## STATEMENT OF BASIS FOR ISSUANCE OF CLASS VI UNDERGROUND INJECTION CONTROL (UIC) PERMITS

Permit Numbers: IL-137-6A-0001, IL-137-6A-0002, IL-137-6A-0003 and IL-137-6A-0004

Facility Name: FutureGen 2.0 Morgan County CO<sub>2</sub> Storage Site

Figure 1. The FutureGen project proposed Area of Review including: the modeled  $CO_2$  plume (in yellow) and the predicted area of elevated pressure (the red circle).

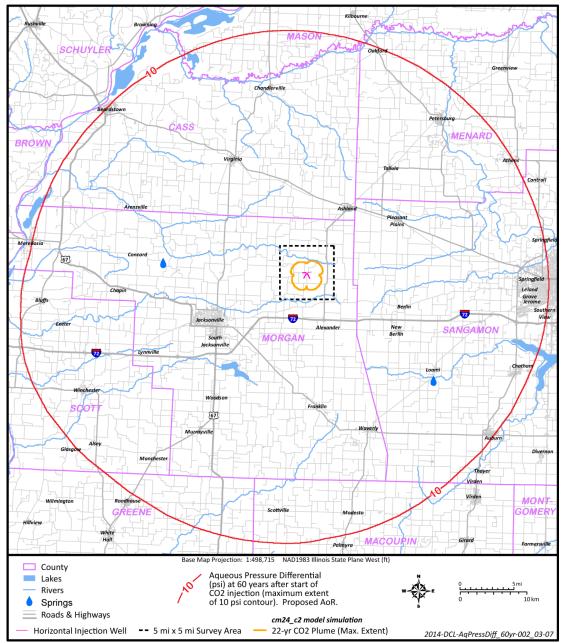
Area of Review and Corrective Action: In accordance with 40 CFR 144.55, 146.6 and 146.84, the Area of Review, or AoR, is the region surrounding the geologic sequestration project where any improperly sealed, completed or abandoned wells that penetrate the injection and/or confining zones could provide a conduit for fluid migration. The AoR for these wells has a radius of approximately 24 miles and was delineated pursuant to 40 CFR 146.84(c)(1) using a computational model that predicts the movement of the carbon dioxide plume and pressure front based on available information about planned injection operations and the subsurface rock formations. Figure 1 is a map of the project AoR.

EPA performed an extensive evaluation of the AoR proposed by the permittee by independently modeling the AoR using the Subsurface Transport Over Multiple Phases (STOMP) multi-phase transport model, based on the site-specific geologic and operational data in the permit application and determined that the AoR delineated by the permittee is sufficiently extensive and meets the requirements of 40 CFR 146.84(c)(1). EPA also evaluated the modeling approach used by the permittee and determined that it meets the requirements for computational models to delineate Class VI AoRs. Information about EPA's independent assessment is available in a report in the Administrative Record for these permit decisions.

Figure 2. A stratigraphic column of the geology at the project site (on the left) including the Mt Simon Sandstone (the injection zone) and the Eau Claire Sandstone (the confining zone) and example well schematics.

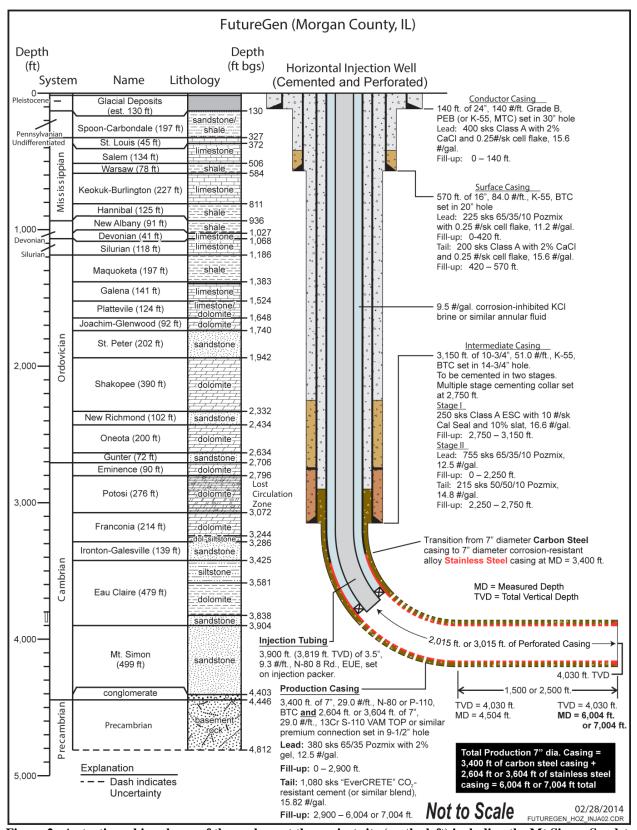
<u>Injection and Confining Zone</u>: Injection for geologic sequestration is limited by the permits to the Mt. Simon Sandstone and the lower member of the Eau Claire Formation (the Elmhurst Sandstone) in the interval between 3,785 feet and 4,432 feet below the ground surface. This injection zone is separated from the lowermost USDW by 1,843 feet of rock, including an impermeable confining zone, the upper members of the Eau Claire Formation (The Lombard and Proviso Members), which will act as barrier to fluid movement. Figure 2 includes a stratigraphic column at the site, including the depth of the injection and confining zones.

criteria of 40 CFR 146.86. All Class VI wells must be constructed with materials and cements that can withstand exposure to CO<sub>2</sub> and CO<sub>2</sub>/water mixtures without excessive corrosion over the life of the project (See Figure 2). Class VI wells must also be cased and cemented to prevent the movement of fluids into or between USDWs. The wells will be equipped with automatic surface shut-off devices that will shut off the wells if any permitted operating parameters (such as injection pressure) diverge from limitations set in the permits. EPA reviewed the proposed well schematics submitted with the permit applications to verify that the cements and other materials proposed for the wells will be compatible with the carbon dioxide stream and planned operations (e.g., injection pressures). Following well construction, pursuant to 40 CFR 146.82(c), EPA will review any final "as built" well schematics to confirm that the wells were constructed to ensure USDW protection, meet the goals of the Class VI Rule at 40 CFR 146.86(a), and are equipped with the required shut-down devices before injection is authorized.
